**IRIS-4 / EDGE**  
Firmware 4.21.8

This document details changes from firmware Version 4.21.2 to Version 4.21.8 for the IRIS-4 & Edge VS/DS terminal families.

### 5.17.3 Additional Cellular mode

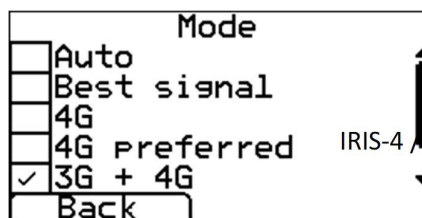
A new cellular mode (3G and 4G only) has been added for installations using SIP Voice over IP to ensure that 2G, which does not have sufficient bandwidth for VoIP audio, is never used.

This setting is now the default for terminal variants EDGE VS5010, VS5051 and VS5053. These terminal types which have earlier versions of firmware will be automatically updated to this setting when reflashing to V4.15.0 or later.

As part of this change the AT command used by Toolbox to read/write this setting has been changed from %G163 to %G206. This prevents Toolbox V4.6.0 inadvertently changing the setting without warning because it does not recognise the 3G + 4G mode. If V4.6.0 or earlier version of Toolbox is used with these terminals, Toolbox will report that it cannot read or write this setting and will not change it. If the old command is used with the terminal via a terminal emulator or via the Toolbox diagnostic tab, it will return ERROR with a note that the command has been replaced.

#### 5.24.6 Manual Removal of Dial Capture Port Voltage

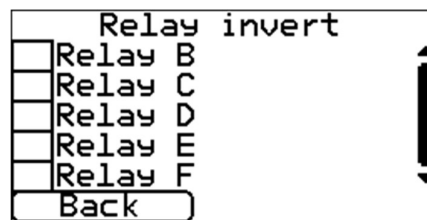
The possibility has been added for the AddSecure Connect service support staff to manually remove the terminal dial capture port voltage. This can be used to reset attached line powered panels if necessary.

#### 5.24.9 Changes to EN54-21 Fire Mode

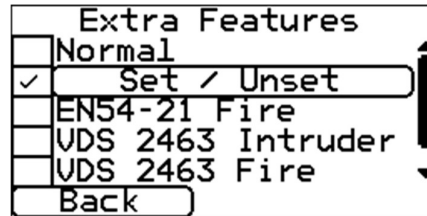
When the existing EN54-21 Fire mode is selected (as below), the settings of Pin inputs 1 and 2 and Relay outputs A and B cannot be changed. This protect the use of these pins and relays. In EN54-21 Fire mode, pin inputs 1 and 2 are set to report Fire Alarm and Fire Fault from the alarm panel and Relay outputs A and B are set to report Fault and Alarm Acknowledge back to the Fire panel.

#### 5.24.10 Changes to Cellular Bridging Mode

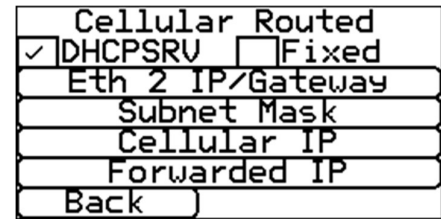
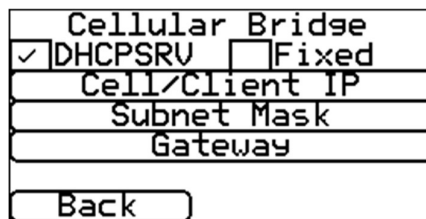
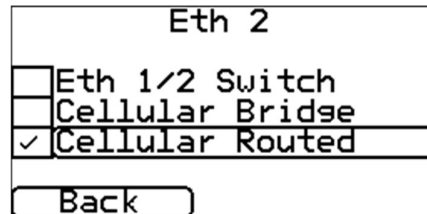
The Cellular to Eth2 option has been revised and improved. There are now two options - Cellular Bridge and Cellular Routed. Cellular Bridge maps the device connected to the Eth 2 socket to same IP address as the SIM card. Cellular Routed offers mapping to a configurable device IP address and Eth2 IP address. There is a DHCP server with the terminal that can be enabled in both modes that means that the connected device does not have to be manually configured with an IP address if it supports DHCP.

By default the Cellular Routed mode is selected, with Forwarded IP (i.e. the address of the attached device) set to 192.168.1.1 and the Gateway IP (i.e. the address of the Eth2 connection on the terminal) set to 192.168.1.254. The DHCP server is on by default.

### 5.31.3 Modified Support for Vanderbilt SPC Panels via Ethernet

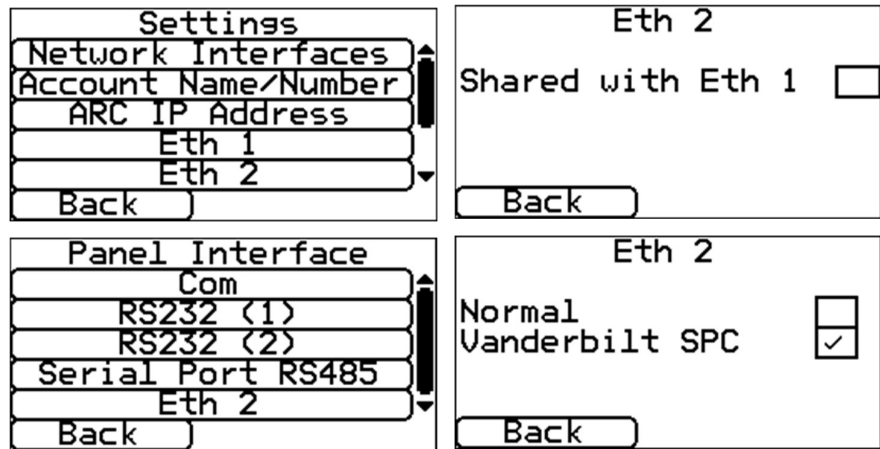
For some time, IRIS 4xx terminals, which have two Ethernet interfaces, have been capable of supporting connections from Vanderbilt (formerly Siemens) SPC panels via Ethernet and forwarding alarms from the panel to ARCs equipped with an IRIS Secure Apps system. This function has been extended to the new IRIS-4 6xxD products as well.

There has been a modification to the way this works, driven by the fact that Microsoft's Dial-up Networking function is no longer supported in Windows 10 in the same way as it was on earlier Windows versions. This means that remote access to the panel from Siemens SPC Pro software is no longer possible using the combination of Dial-up Networking and the IRIS Remote Service App. Therefore, an alternative way of supporting SPC Pro connection via AddSecure's Link service has been provided. The same can also be done with any SIM card that provides remote connection from an external IP source.

- 4) The IP Address and Remote Access settings have been removed from the terminal's touch screen menu as they are no longer required. When selecting Siemens mode, the option 'Shared with Eth 1' is automatically deselected.

#### 5.31.4 ESMI Fire Panel Support

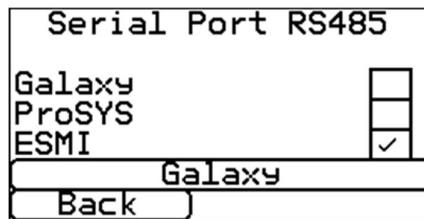
Support for Fire Panel serial interfaces has been extended to include ESMI fire panels on the RS485 port.

#### 5.35.2 Tamper Restore

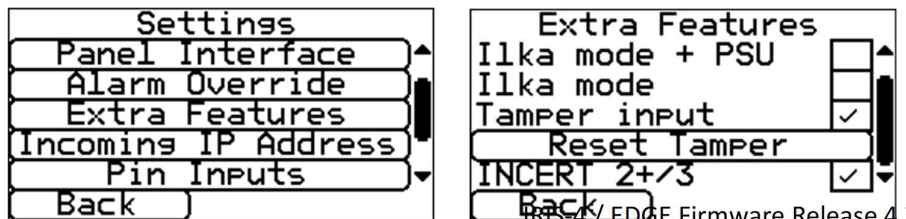
This enhancement has been made for compliance to Belgian Incert standards and is only applicable if 'INCERT 2+/3' mode has been selected on the Touch Screen->Extra Features menu.

If a tamper switch activation occurs (including activation of the tamper input on non-cased variants), it does not restore automatically, it must be restored via the Touch Screen->Extra Features menu 'Reset Tamper' button.

If the tamper physical condition has been restored before 'Reset Tamper' has been selected, the reset button will be removed and the tamper restore message will be sent to the monitoring centre. If not, the button will be removed and the tamper restore will be sent when the condition is restored.

### 5.35.3 Cellular Mode

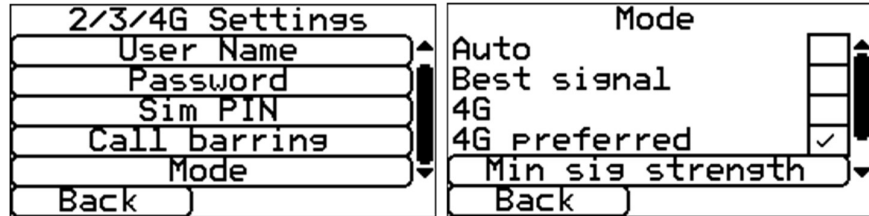
A Cellular Mode setting menu has been added to the 2/3/4G settings menu to select the Cellular technology used.

- 2G - as '4G' but fixed to 2G.
- 2G preferred – as '4G preferred' but 2G is selected if available and above the minimum signal strength specified.
- Enhanced roaming – the same function as available on the previous version of software.

### 5.35.4 'Fail to Communicate' Relay output

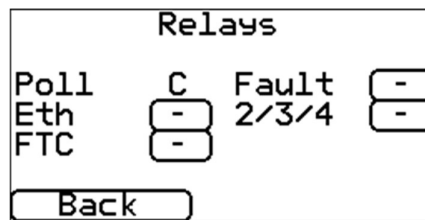
A relay can be selected to indicate 'Fail to Communicate'. This is found in the 'Trouble Reporting' 'Via Relays' menu.

### 5.35.5 Relay Invert Setting

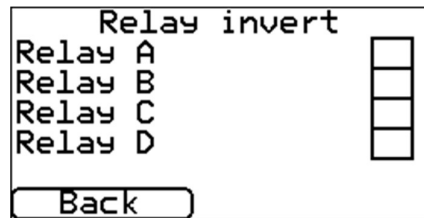
A relay invert setting is available in the 'Relays' menu.

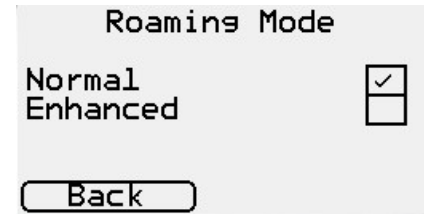
On the IRIS Touch NG series, the installation wizard included a selection tick box for 'Roaming SIM', as below.

This was removed from this menu on the IRIS-4 series because the meaning of the selection was ambiguous. The intention of the setting is 'enhanced' roaming where the terminal monitors the signal strength of the signal from all available cellular service providers and selects the one with the highest signal strength. It was identified that the setting was being selected by some installers if the SIM card in use is a roaming enabled SIM card and where there was no need for the selection of the operator with the strongest signal, as described above. This could result in intermittent trouble being reported by the terminal to the monitoring centre. The selection of this feature, for those who need it, has therefore been moved to the settings menus.

#### 5.38.2 Selection of Preferred Technology

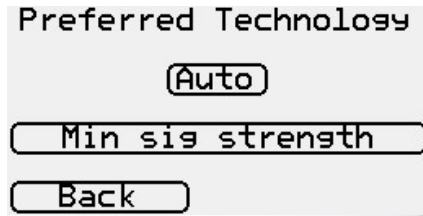
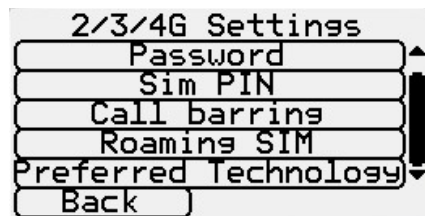
This setting allows the installer to select the preferred technology (Auto, 2G, 3G or 4G) used by the dialler for its cellular connection and the minimum signal strength required for the connection. If the signal strength is not at the required level (default is 10), the terminal will use a different technology that does meet the requirements. A setting of 'Auto', which is the default, instructs the terminal to select the technology with the highest signal strength, as with IRIS Touch NG terminals.
